NOTICE OF MEETING

4.1 PA2021.0125 - 139 WAVERLEY ROAD DON - 2 LOT SUBDIVISION

That the Planning Authority, pursuant to the provisions of the *Tasmanian Planning Scheme – Devonport 2020* and Section 57 of the *Land Use Planning and Approvals Act 1993*, approve application PA2021.0125 and grant a Permit to develop land identified as 139 Waverley Road, Don for the following purposes:

Figure 3 - Proposed subdivision plan

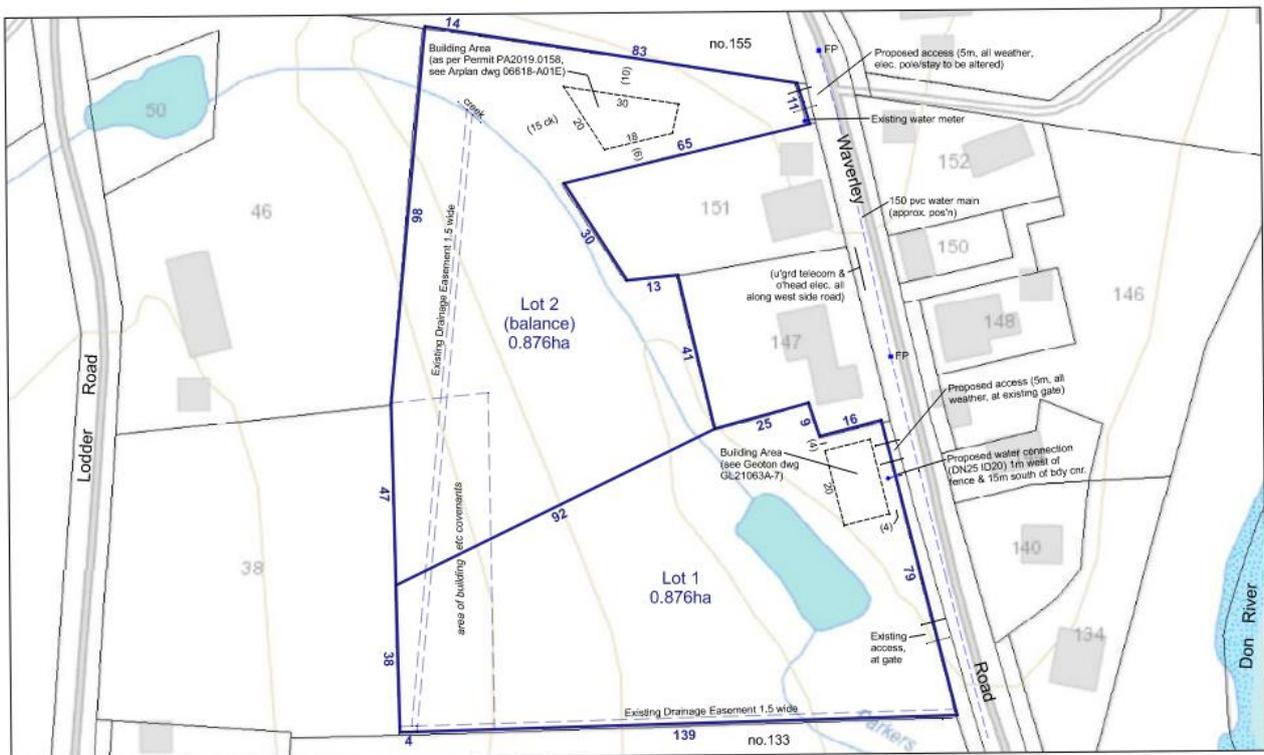
The building envelope on Lot 2 meets the setback requirements, however the building envelope on Lot 1 is located 4m from the front and side boundaries. These setbacks are in keeping with the pattern of development on established properties in the area and necessary as a result of the topography and landslide hazard areas located on the site.

Comment – Lot 1 has a 79m frontage and meets the acceptable solution. Lot 2 has an 11m frontage and must be assessed against the performance criteria.

Lot 2 will provide sufficient room to manoeuvre onsite and no other lots will use the land for access. A number of other lots in the area have frontages of a similar width or less and the proposed frontage exceeds the minimum 3.6m requirement.

A power pole is currently located in front of the proposed access and may require relocation. Consultation with TasNetworks is required in this regard.

Comment – The building envelope shown on the geotechnical investigation report for Lot 2 is located 56m into the property from the frontage on the northern side and 30m from the frontage on the southern side. This is not in keeping with the building envelope shown on the proposed subdivision plan. As such, the plan requires amendment to reflect the building envelope identified by Geoton Pty Ltd. This also reduces encroachment on the Waterway and Coastal Protection Area.

2. Building envelopes, including areas for on-site wastewater disposal and bushfire hazard management areas, are to be identified on the final plan. The building envelope for Lot 2 is to be drawn in accordance with Site Plan, Project No. GL19100A, Figure No. 6, dated 7/5/2019 by Geoton Pty Ltd.

8. The developer is to contact TasNetworks regarding driveway access for lot 2. The developer must comply with any requirements of TasNetworks.

Figure 5 - Plan showing minimal encroachment of onsite wastewater distribution beds on watercourse setback

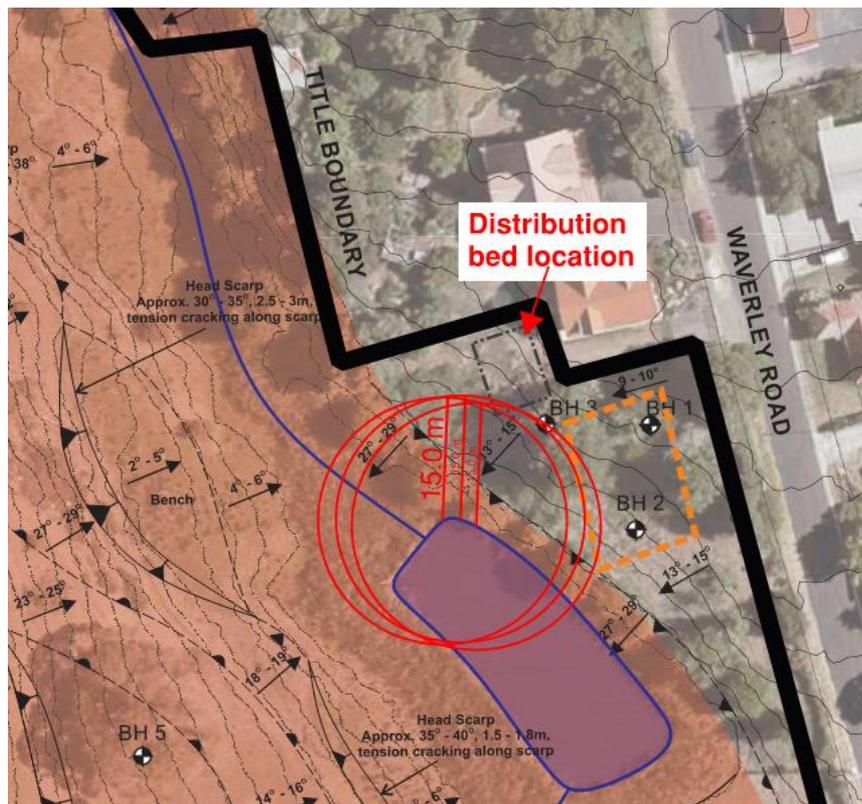
The representation raises questions in regard to lot size, setbacks, encroachment of bushfire hazard management areas on priority vegetation and waterway and coastal protection areas and the pattern of development in the area. In addition, questions are raised in regard to on-site wastewater disposal and the issue that the proposed distribution bed may be located less than 15m from the watercourse as required by relevant standards.

In regard to the impact of the proposed aerated wastewater treatment system and distribution beds on the Waterways and Coastal Protection Area, and the fact that the location shown on the plan is within 15m of the watercourse, it is acknowledged that the distribution beds do not have to be rectangular and may take any shape.

This means that the distribution beds can be designed in such a way to ensure they do not encroach on any of the setbacks required from boundaries or watercourses. The disposal area will, however, encroach on the Waterway and Coastal Protection Area. Impact on the watercourse will be minimised through compliance with the required setbacks from the watercourse for any future on-site wastewater system and through the implementation of erosion control measures to ensure sediment does not wash into the watercourse.
